SHEET 3 OF 3

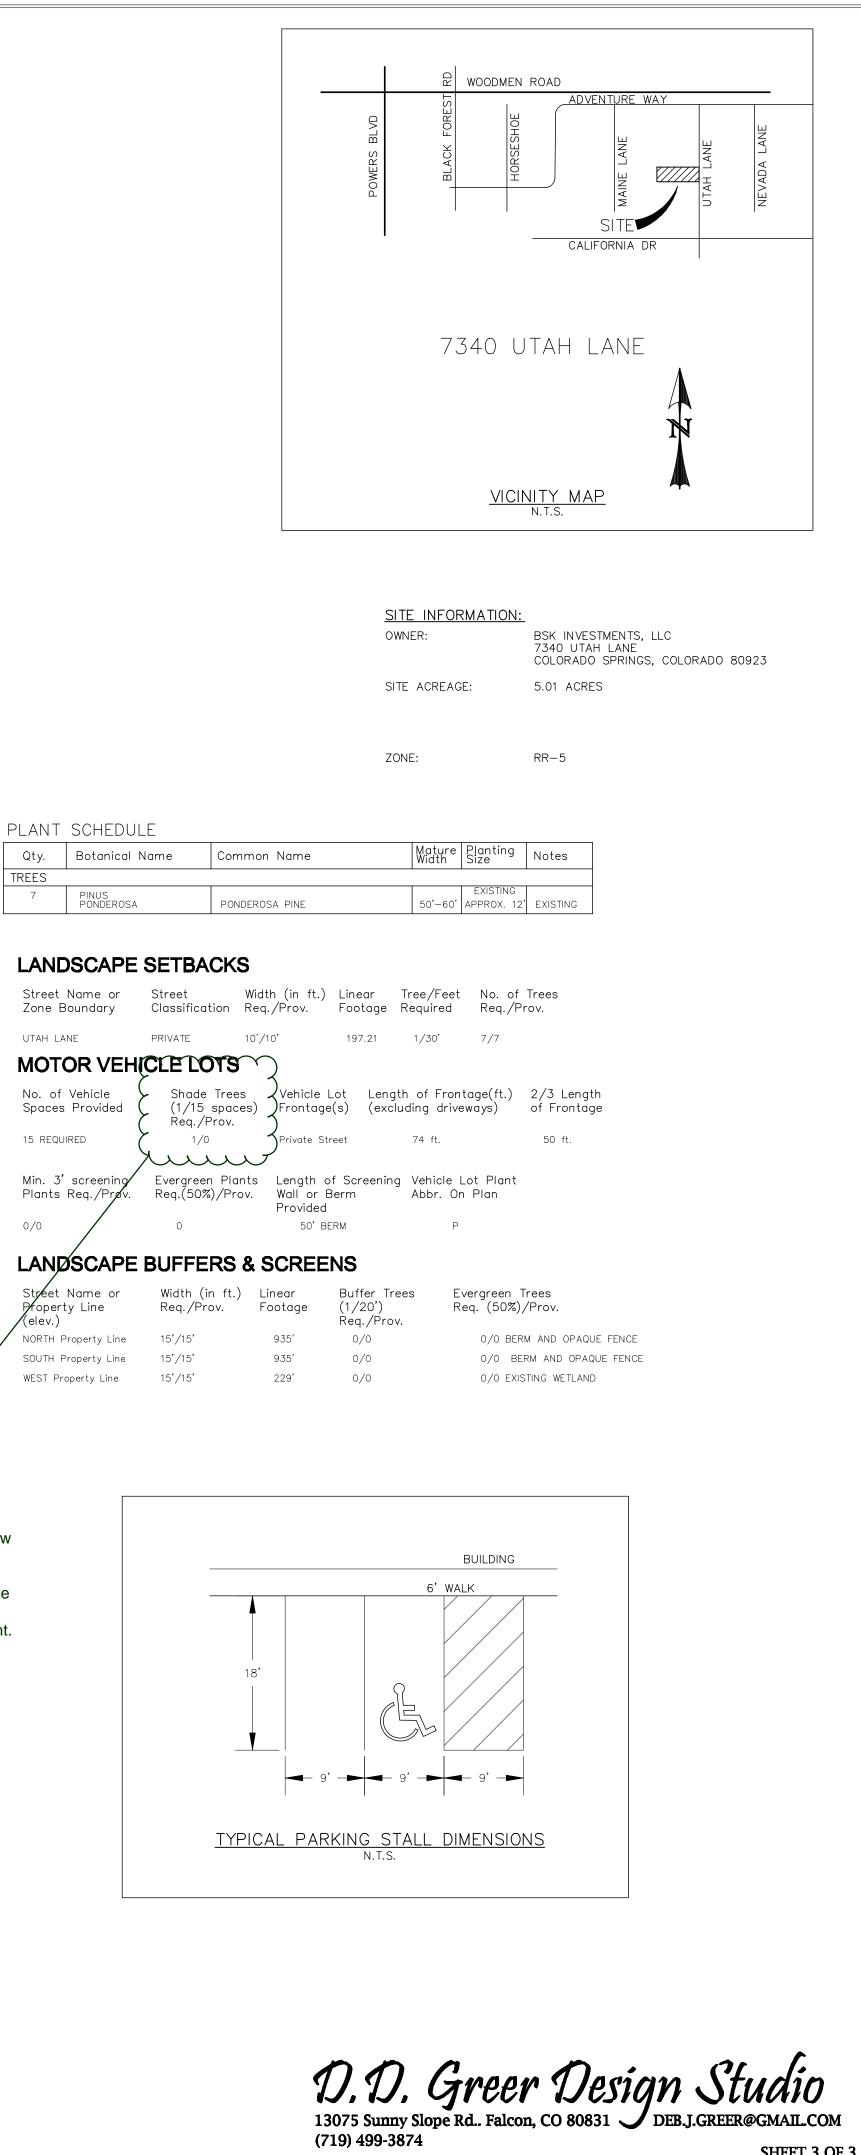
disagrees with the total required in the letter of intent. Also, because this is a new request, you should provide request for alternative landscape per LDC 6.2.2(A)(4) in your letter of intent.
